CONSTRUCTION MANAGEMENT CHANGE PROPOSAL

Re: Our Change Proposal 25069-02 for **Additional Crack Repairs per Owner's Instruction**

Project: Delray Beach CRA Exterior and Interior Art Warehouse Repairs | 313 N.E. 3rd Street, Delray Beach
Arts Warehouse
Arts Warehouse, 313 N.E. 3rd Street, Delray Beach, FL 33444

25069 - 02 - Additional Crack Repairs per Owner's Instruction

- S1.0 - STRUCTURAL FLOOR PLAN - CRACKS FIRST PHASE

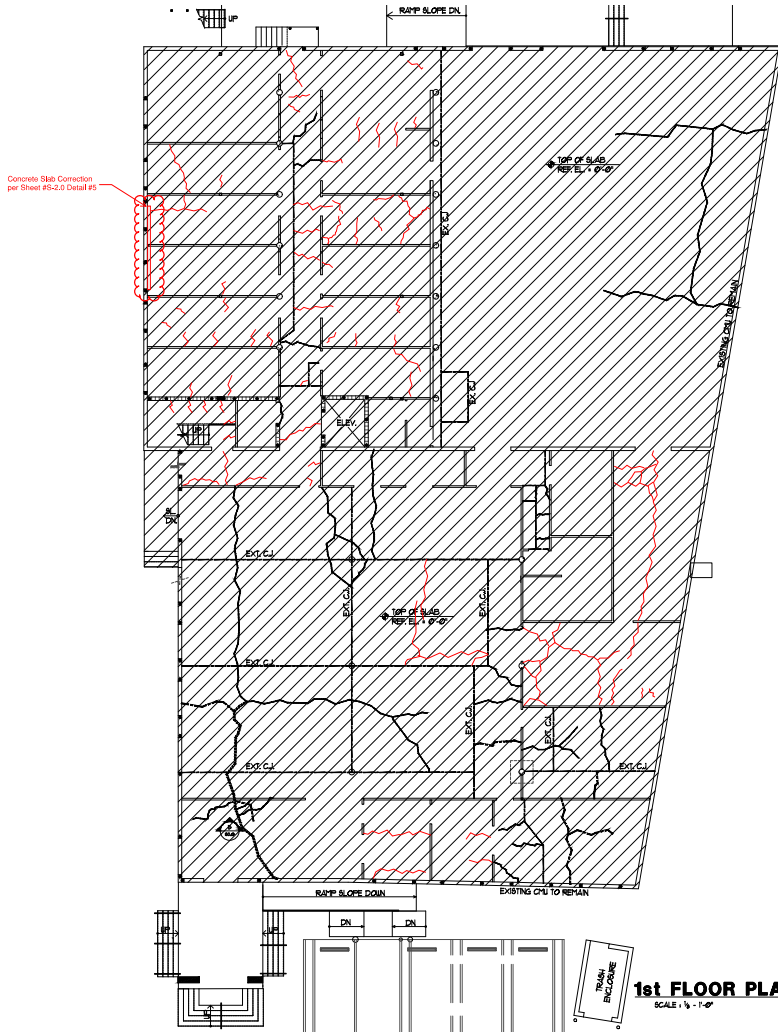
Per instructions provided by the Project Owner and Architect of Record under RFI#004, additional cracks identified for Phase 1 (front portion of the first floor) and Phase 2 are outlined in red on the attached structural plan.

Information Requested/Description:	
<p>Please be advised that, based on the mockup samples performed (with backer and without backer, see attached photos), a site evaluation took place on Tuesday and Wednesday, March 31st and April 1st, following the previously reviewed and approved submittal package, with all prior comments addressed through the mockup, and no outstanding items remaining.</p> <p>This RFI is submitted to obtain formal confirmation and approval of the selected repair method and finish condition. Please confirm that the approved finish is acceptable in terms of aesthetics, texture, surface condition, and color, and that the Contractor shall replicate this approved mockup standard for all crack repairs throughout the project.</p> <p>Additionally, please be advised that, during a site walkthrough with the Owner and AOR, and based on Sheet S1.0 – First Floor Plan, it was identified that the repair scope is to be extended by approximately 50 LF, beyond the originally defined limits per the contract drawings.</p> <p>Waypoint Contracting (WCI) has received a preliminary cost from the Vendor in the amount of \$42/LF plus WCI O&P + fees as necessary for this additional work. Please note that this walkthrough and associated quantity apply only to the first phase (front area) and do not include the remaining areas at the rear of the first floor or second floor, which will be evaluated in future walkthroughs which may lead to additional costs.</p> <p>Please confirm formal approval of the mockup finish standard and advise on how to proceed regarding the additional scope and associated cost.</p>

Responded By:	Walt Sanchez, <i>CRA Project Manager</i> Delray Beach Community Redevelopment Agency
Returned Date:	04/03/2026
Answer:	The mockup of the floor crack repair is acceptable to the city with the understanding that the cutting and routing of the crack will be neat in nature and the crack repair material is fully and properly applied within the crack with no voids or gaps.
